**REMODEL & ADDITION**  
**NEZHAD RESIDENCE**  
285 LEAF STREET  
LONG LAKE, MN

**A-1**  
OF 2

**CITY OF ORONO**  
BUILDING PERMIT PLAN REVIEW  
INSPECTOR *[Signature]*  
DATE 7-21-05 PERMIT NO. \_\_\_\_\_  
☐ APPROVED AS SUBMITTED  
☒ APPROVED WITH CORRECTIONS AS NOTED  
☐ NOT APPROVED -- CORRECT & RESUBMIT  
These comments are for your information. All work shall be done in full accordance with all applicable building and zoning code. Regulations including items not specifically noted in this review. KEEP THIS PLAN SET ON SITE AT ALL TIMES

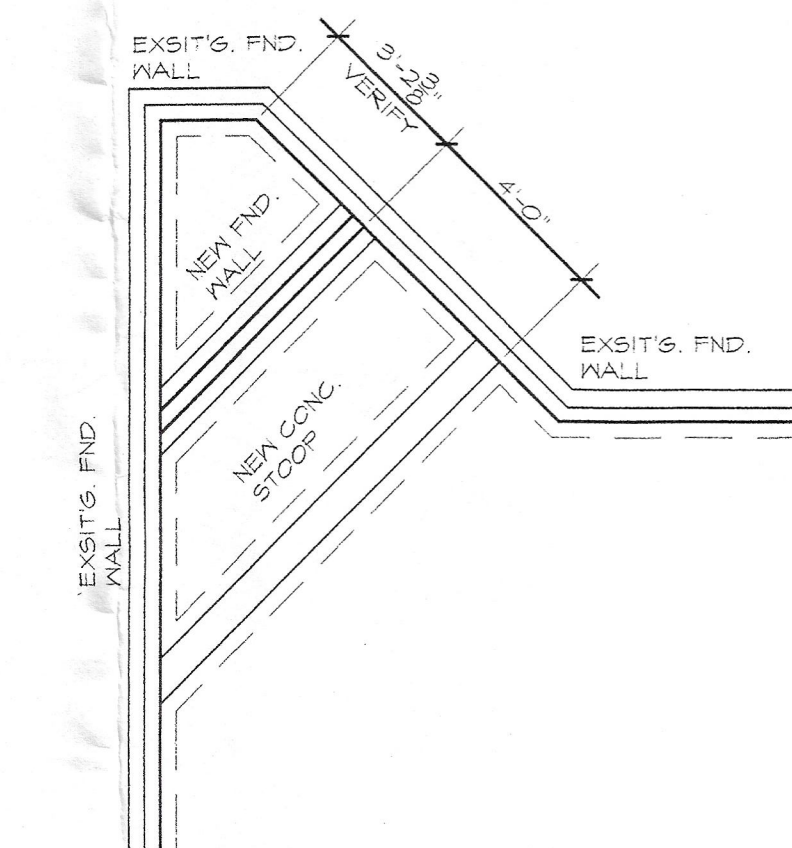
PROVIDE PUMP AND/OR  
PLBG. ACCESS  
THROUGH TILE UNACCEPTABLE

**BEDROOM WINDOWS**  
FIRE EXIT REQUIRED  
20" MIN. CLEAR WIDTH  
24" MIN. CLEAR HEIGHT  
5.7 SQ. FT. MIN. OPENING  
44" MAX. SILL HEIGHT

**SPECIAL NOTE**  
SEE ATTACHED SHEET  
FOR ~~SMOKE DETECTOR~~  
CODE REQUIREMENTS
